From: Mike Gaither
To: [Saxton, John](#)
Cc: [John Cash](#)
Subject: [External_Sender] Revised Lost Creek Met Data Report
Date: Tuesday, February 06, 2018 7:00:02 PM
Attachments: [LC Met Data Report SUA-1598_17Nov2017rev2.pdf](#)

METEOROLOGICAL DATA EVALUATION TO DEMONSTRATE LONG-TERM
REPRESENTATIVENESS AT THE LOST CREEK ISR PROJECT

LOST CREEK ISR, LLC

November 17, 2017
(Revised February 6, 2018)

FIGURE 7

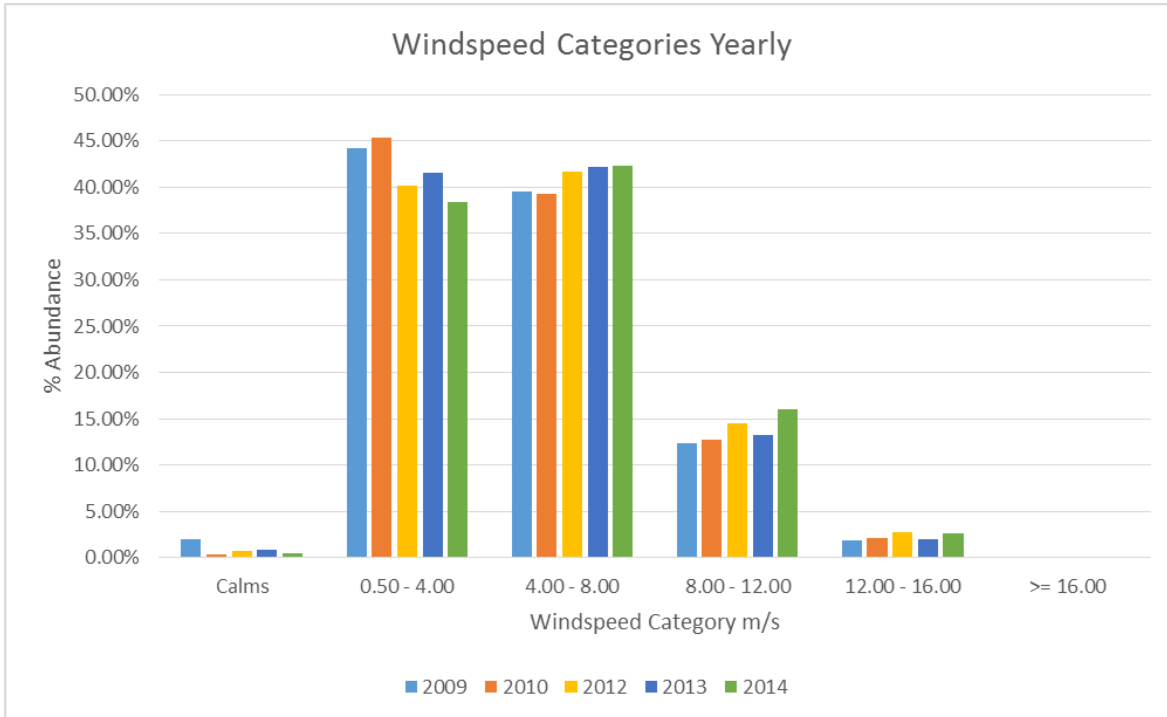
- Figure 7
- Table 4
- Appendix A

The revisions include corrections for the wind speed categories. The units of the wind speed input data for the wind rose program were incorrect. The corrections to the input data were made and also the wind speed categories were adjusted to coincide with the categories for the wind roses provided in the Lost Creek East Amendment Technical Report (Figure D4-3).
